UNITED STATES PATENT AND TRADEMARK OFFICE

APPLICATION NO.	FILING DATE	FIRST NAMED INVENTOR	ATTORNEY DOCKET NO.	CONFIRMATION NO.
10/568,670	05/19/2006	Peter Schwarzler	GKNG 1278 PCT	2727
27256	7590	12/10/2008	EXAMINER	
Dickinson Wright PLLC 38525 Woodward Avenue Suite 2000 Bloomfield Hills, MI 48304			LOUDEN, CLIFFORD J	
			ART UNIT	PAPER NUMBER
			3679	
			MAIL DATE	DELIVERY MODE
			12/10/2008	PAPER

Office Action Summary	Application No. 10/568,670	Applicant(s) SCHWARZLER ET AL.	
	Examiner CLIFFORD J. LOUDEN	Art Unit 3679

DETAILED ACTION

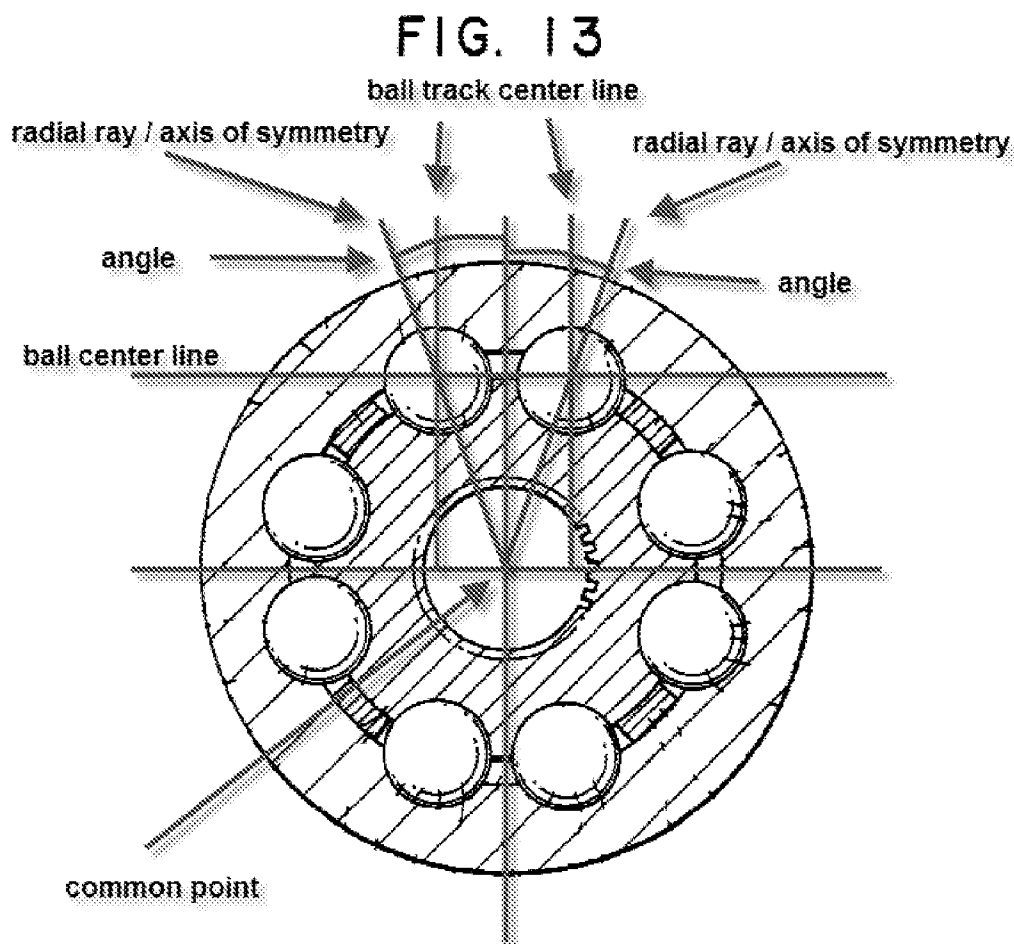
4. Claims 1, 14-15, 19-21 & 29 are rejected under 35 U.S.C. 102(b) as being anticipated by Ouchi et al., US 2001/0021671 (Ouchi). As to claim 1, Ouchi shows in Fig. 13 a constant velocity fixed joint (301d) comprising: an outer joint part (303B) having a longitudinal axis (directed into the figure), and an attaching end and an aperture end positioned axially opposite one another (inherent to constant velocity joints and exemplified in Fig. 5), and outer ball tracks (308); an inner joint part (302A) having a longitudinal axis (directed into the figure), an attaching mechanism for a shaft pointing towards the aperture end of the outer joint part (inherent to constant velocity joints and exemplified in Fig. 5), and inner ball tracks (307), the outer ball tracks and the inner ball tracks form pairs of tracks which each accommodate a torque transmitting ball, wherein each two adjoining pairs of tracks comprise outer ball tracks whose center lines are positioned in planes (shown in the examiner marked diagram below and labeled as “ball track center line”) which extend substantially parallel relative to one another, and inner ball tracks whose center lines are positioned in planes (shown in the examiner marked diagram below and labeled as “ball track center line”) which extend substantially parallel relative to one another; and an annular ball cage (309d) between the outer joint part and the inner joint part and comprising circumferentially distributed cage windows which each accommodate the torque transmitting balls of two of said adjoining pairs of tracks; wherein, in an aligned joint, centers (shown in the examiner marked diagram below and labeled as “ball center line”) of the balls are held by the ball cage in the joint center plane (inherent to constant velocity joints and exemplified in Fig. 6) and, when the joint is articulated, the ball centers are guided onto the

angle-bisecting plane (exemplified by Fig. 21) between the longitudinal axes, and wherein track cross-sections of the outer ball tracks and the inner ball tracks of each pair of tracks are symmetrical relative to axes of symmetry (shown in the examiner marked diagram below and labeled as “radial ray/axis of symmetry”) which, together with the outer and inner ball track planes, form identically sized angles (shown in the examiner marked diagram below and labeled as “angle”) opening in opposite directions, and each comprise a common point (shown in the examiner marked diagram below and labeled as “common point”).

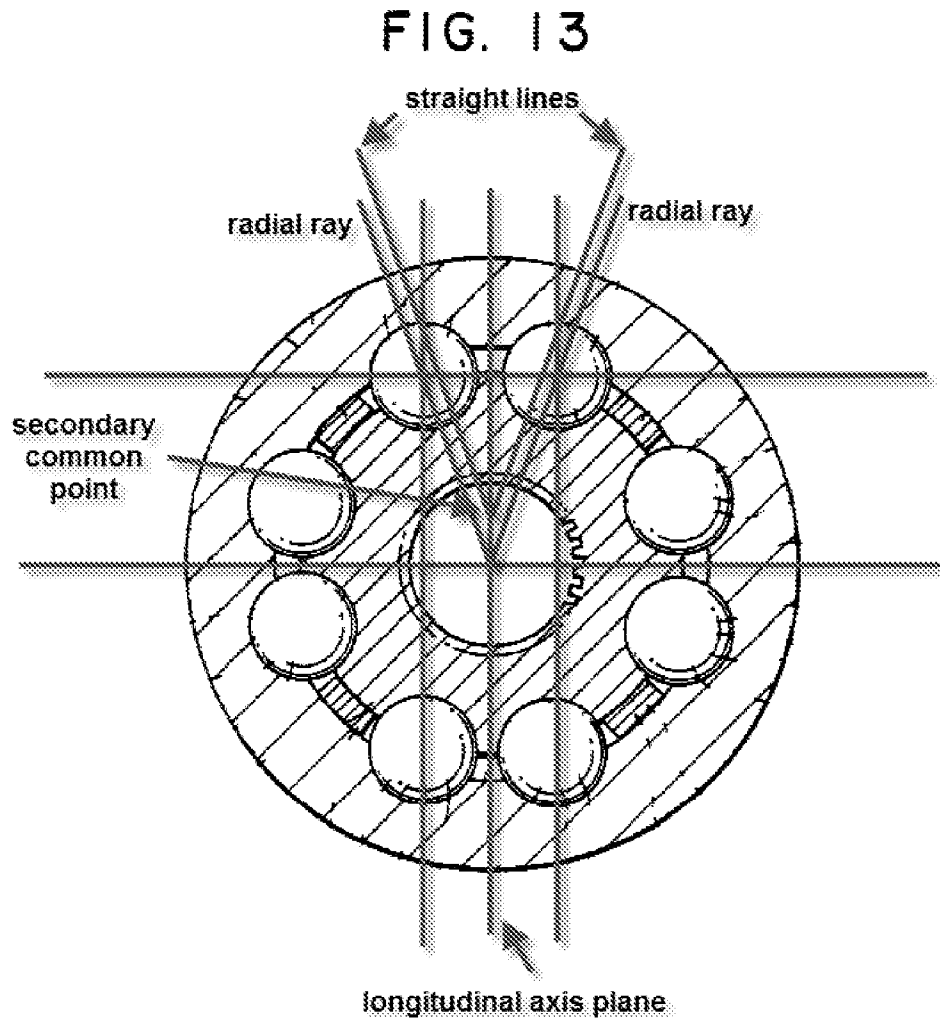
Claim 14: Ouchi shows the track cross-sections of the outer ball tracks and of the inner ball tracks of each pair of tracks are each symmetrical relative to radial rays (shown in the examiner marked diagram above and labeled as “radial ray/axis of symmetry”) from the longitudinal axes through the ball centers of the torque transmitting balls of the pair of tracks.

Claim 15: Ouchi shows the track cross-sections of the outer ball tracks and of the inner ball tracks of each pair of tracks are each symmetrical (about a line, running through the ball centers and perpendicular to the straight lines) relative to straight lines (shown in the examiner marked diagram below and labeled as “straight lines”) which are positioned in a cross-sectional plane and which extend parallel to radial rays (shown in the examiner marked diagram below and labeled as “radial ray”) from the longitudinal axes through the ball centers of the torque transmitting balls of the pair of tracks and which intersect one another in a common point (shown in the examiner marked diagram below and labeled as “secondary common point”) at a distance from the longitudinal axes.

Claims 19-21: Ouchi shows the track center lines of the outer ball tracks and of the inner ball tracks are positioned in planes (shown in the first examiner marked diagram above and labeled as “ball track center line”) which extend parallel relative to one another and parallel relative to the longitudinal axes of the joint and which extend through the ball centers of the balls of two of said adjoining pairs of tracks.

FIG. 6

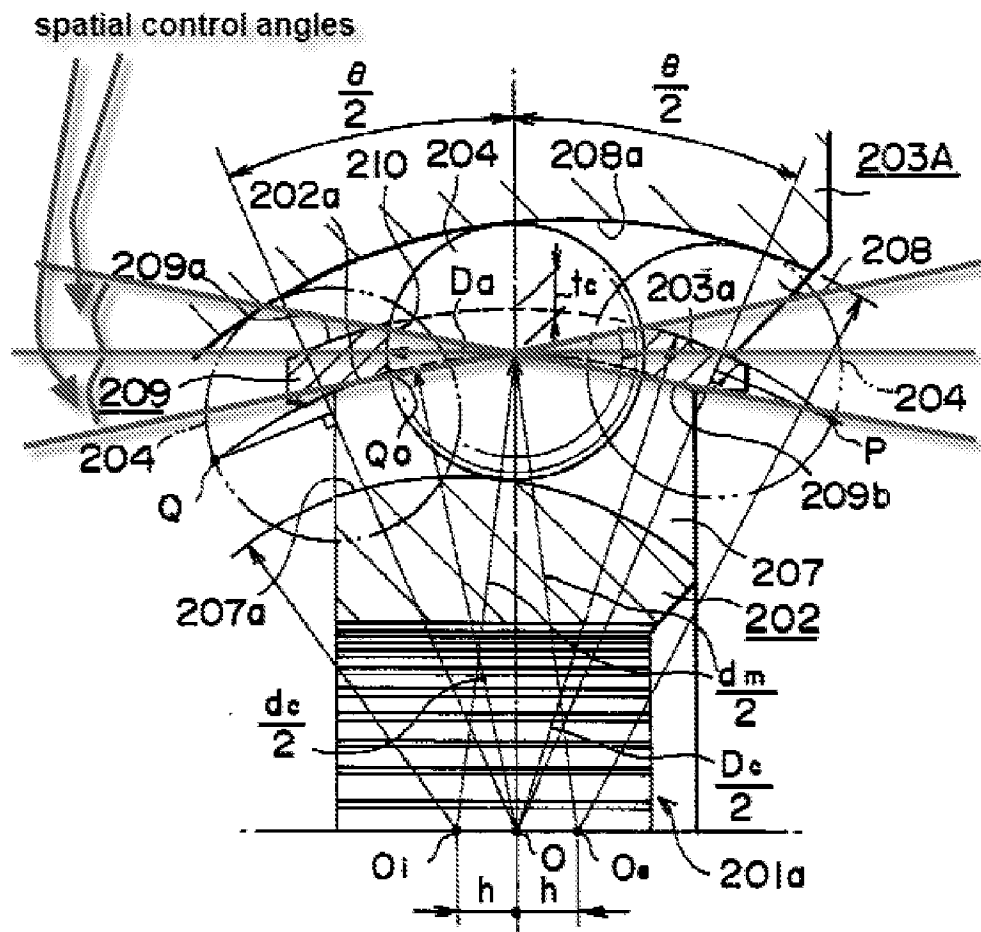
As to claim 27, Ouchi does not expressly disclose the angles of intersection (γ_0, γ_0') are selected in such a way that spatial control angles (ϵ_0, ϵ_0') of the pairs of tracks at the balls have the same value irrespective of whether the load turns clockwise or anti-clockwise. However, it appears that the angles of intersection selected (i.e. 0 degrees) were selected in such a way that the spatial control angles (as exemplified in the examiner marked diagram below and labeled as "spatial control angles") of the pairs of tracks at the balls have the same value irrespective of whether the load turns clockwise or anti-clockwise.

As to claim 28, Ouchi shows a center angle $2\phi_0$ (being the summation of the angles formed between the radial rays) between radial rays (as described above) through the ball centers of the balls of two of said adjoining pairs of tracks. Ouchi does not expressly disclose the angle of intersection (γ_0) is calculated in accordance with the equation $\gamma_0 = \varepsilon_0 \times \tan\phi_0$. However, it would have been obvious to one of ordinary skill in the art through engineering design and
